Technical Service Bulletin: TSB220210

Improved Injector Upper Plunger Assembly

Figure 4, Recon® Injector Serial Number Labelling on Top Stop.

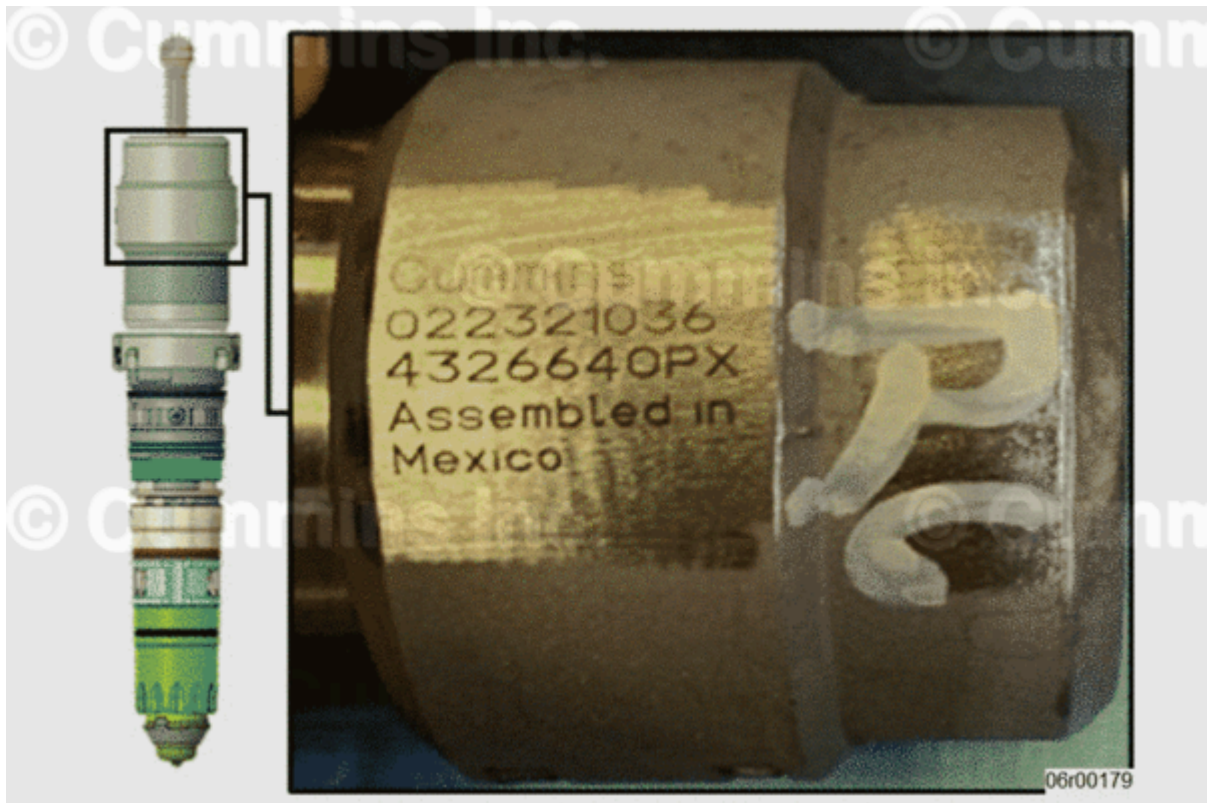
- Any injectors with a serial number between 070120XXX to 051622XXX **must** be quarantined.

Figure 5, Certified Recon® Injector Identification.

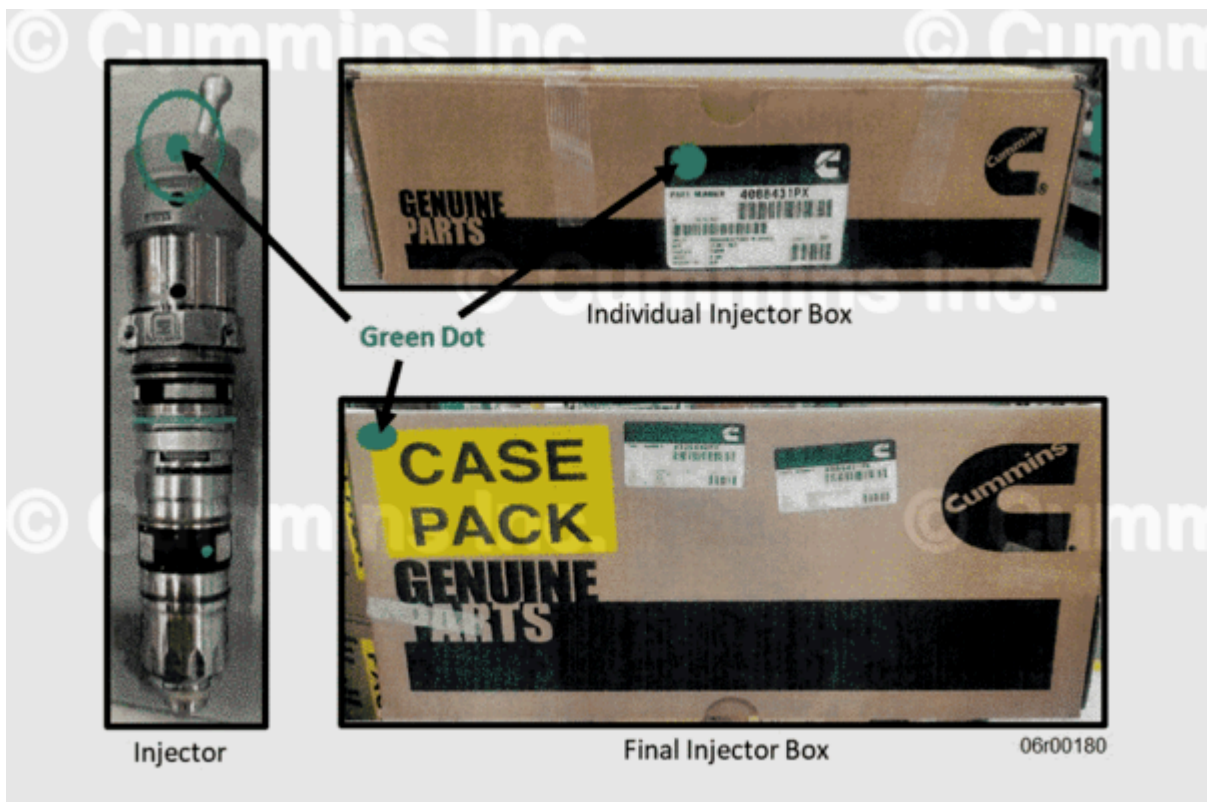
- In addition to the serial number, a green dot has also been applied to the top stop on the injector, the individual injector box and the final shipping box as shown in Figure 5.
